Modification Recommended Service Note

J7201C Attenuation Control Unit, DC to 26.5 GHz, 0 to 101 dB, 1-dB Steps

Serial Numbers: MY59400001 to MY61410049

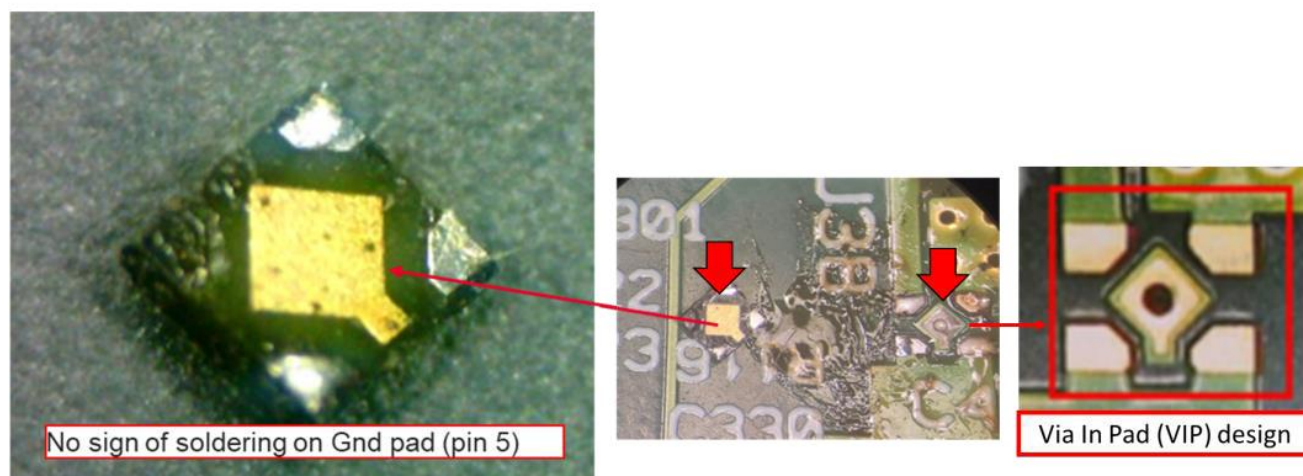
The instrument is unable to boot up and is stuck on the boot-up screen as follows. It is not functioning.

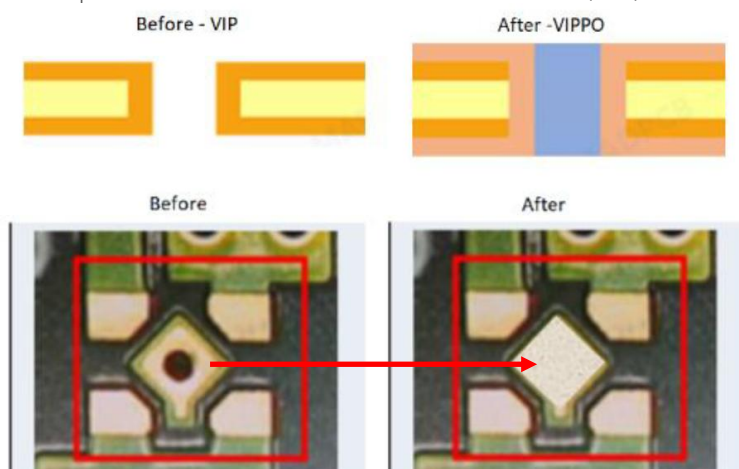
Failure analysis had indicated defective on P0600-63004 board where insufficient solder was observed at 2 locations. The insufficient solder was due to Via in Pad (VIP) where the melted solder had flown to the secondary side of the PCB.

The improvements were made from Via in Pad (VIP) to Via in Pad Plated Over (VIPPO) as per below.

The improved PPMC board have Serial number P06006300423241300007 onwards.

Replace PPMC board P0600-63004 with PPMC board serial number P06006300423241300007 onwards where 13 is the work week and 24 is the year.
